**Inspection Report of 1076 Fleming Way Stuart FL 34997  
Prepared for Mr & Mrs Stander**

# Inspection Report of 1076 Fleming Way Stuart FL 34997 4.23.06

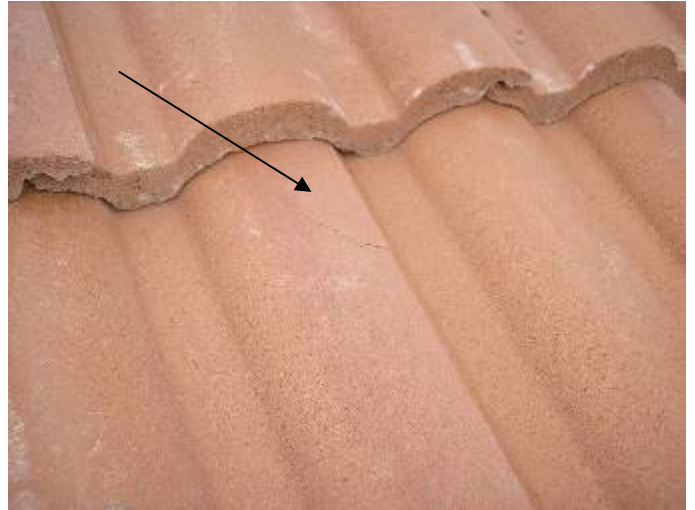
Some of the hip & ridge cap tiles do not have the correct overlap (headlap). The overlap is required to be at least 2 inches at adhesive or mortar set tiles. §1518.8.11

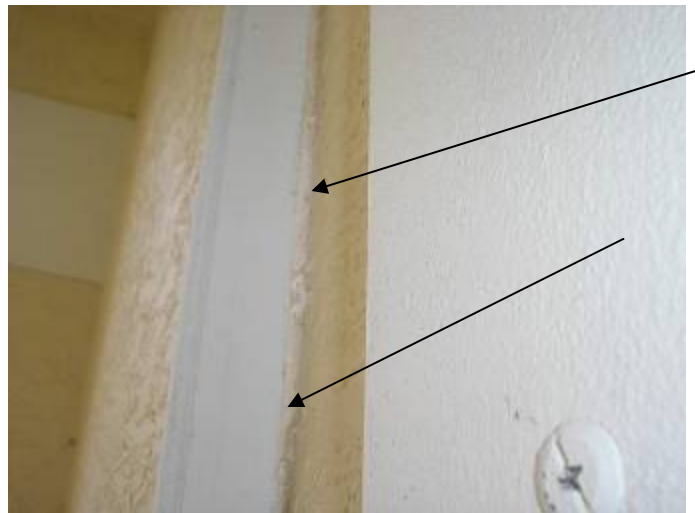
The stucco at some at the walls is concave or curved in & does not appear to be the correct thickness. §2509.1.1

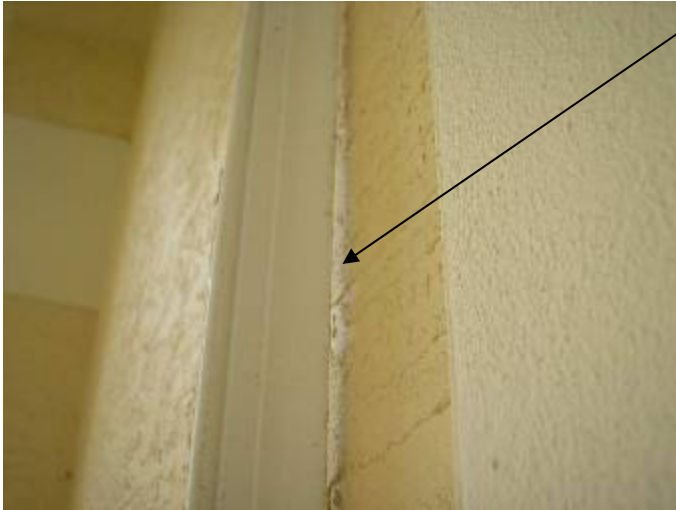
The stucco at some at the walls is concave or curved in & does not appear to be the correct thickness. §2509.1.1, ASTM C 926

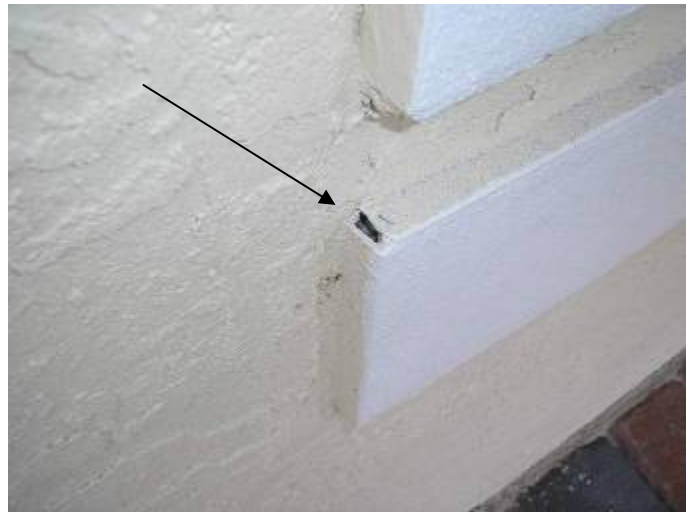
Damaged areas & unsealed openings in the stucco trim & Styrofoam banding need to be corrected. §13-606.1.ABC.1.2

All openings in the building envelop need to be correctly sealed. §13-606.1.ABC.1.2

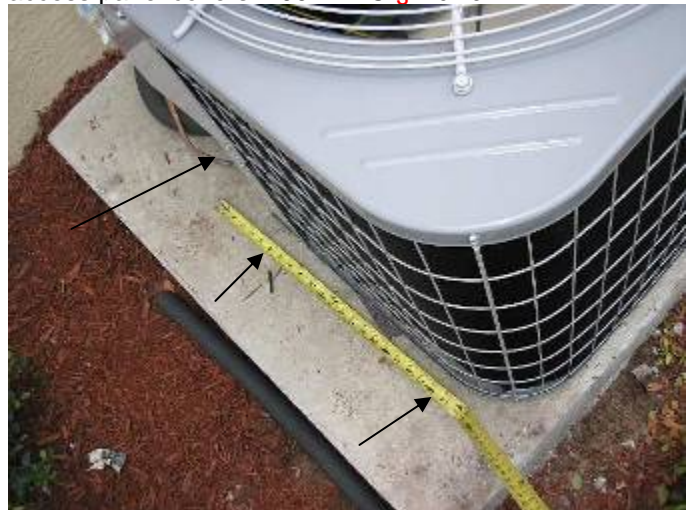
The AC condensing units are turned the wrong way. 36 " working space clearance is required at the electrical access panel covers. 2002 NEC §110.26

The AC condensing units are turned the wrong way. 36 " working space clearance is required at the electrical access panel covers. 2002 NEC §110.26

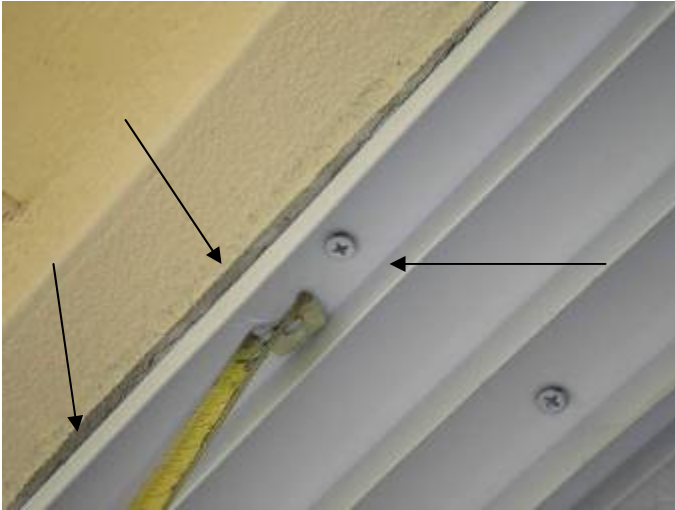
Some of the screw anchors & frames are not correctly set or sealed to prevent water & pest intrusion around the sliding glass doors. §13-606.1.ABC.1.2

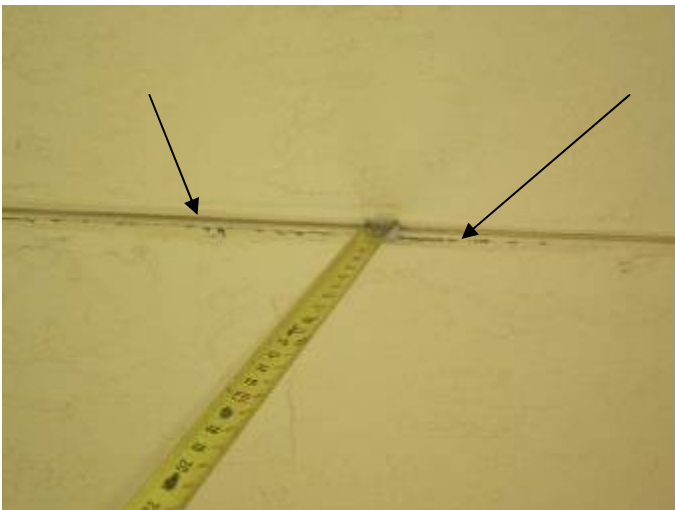
There are unsealed openings in the ceiling & the stucco does not appear to be correctly bonded at the back patio.

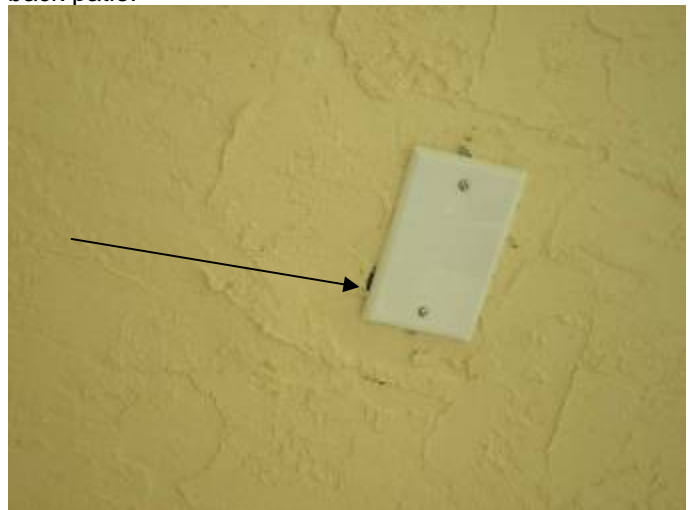
There are unsealed openings in the ceiling & the stucco does not appear to be correctly bonded at the back patio.

There is not enough stucco around the junction box for the cover to fit correctly.

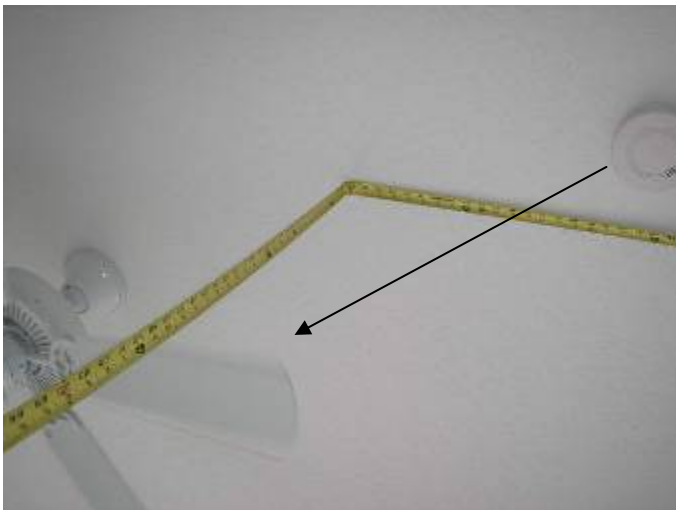
Several of the smoke detectors are too close to the ceiling fan blade tips. 3 ft. horizontal clearance is required.

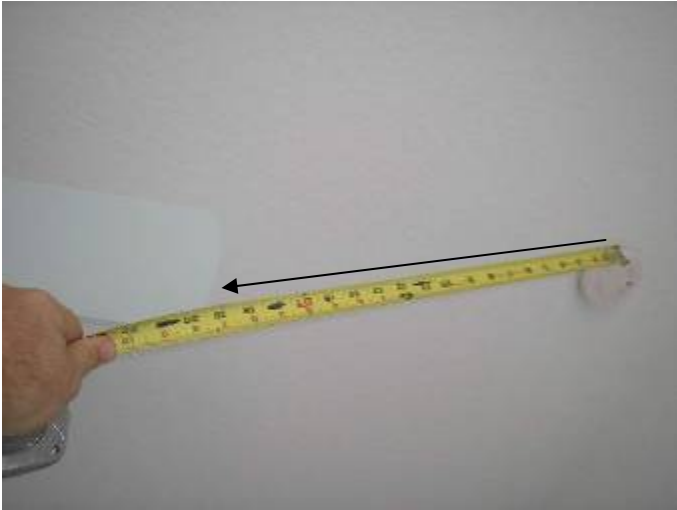
Several of the smoke detectors are too close to the ceiling fan blade tips. 3 ft. horizontal clearance is required.

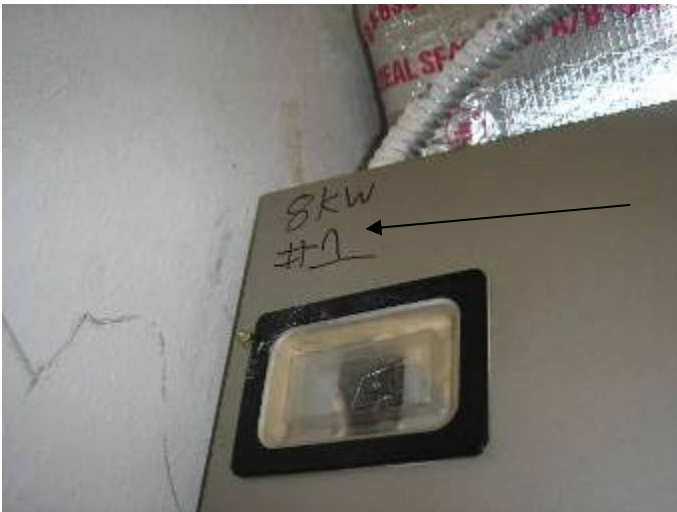
There is not enough clearance around this AC air handler. §13-410.1.ABCD.3.0.3

There is not enough clearance around this AC air handler. §13-410.1.ABCD.3.0.3

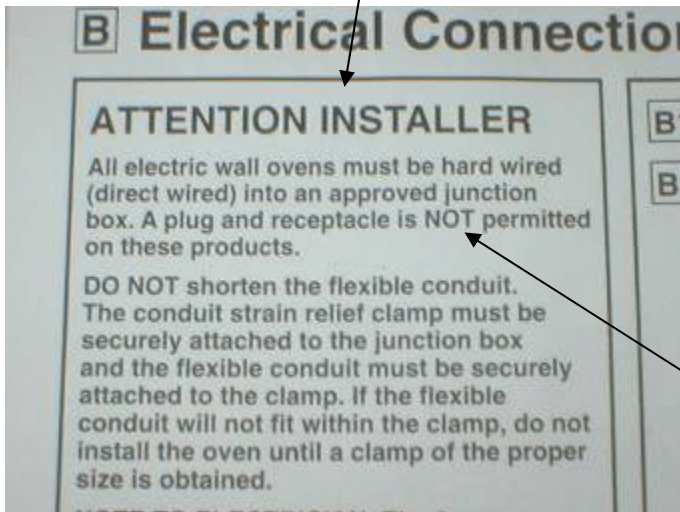
The 60 amp disconnect is too big for the 8kW heating system. A 45 amp breaker should be installed.

The 60 amp disconnect is too big for the 8kW heating system. A 45 amp breaker should be installed.
